Network Video Recorder

Version: V4.32.110 build211009

Release Note

2. 【Added privacy prompts on GUI and web activation and login interface】

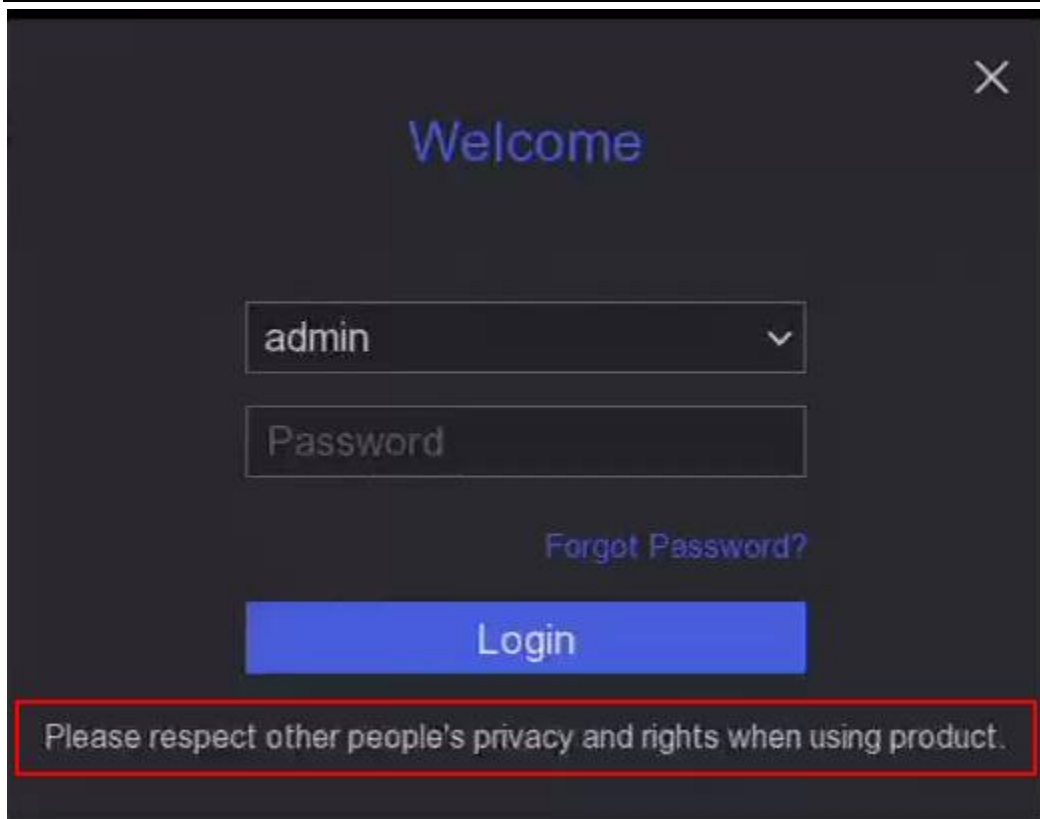
1) GUI

2) Web
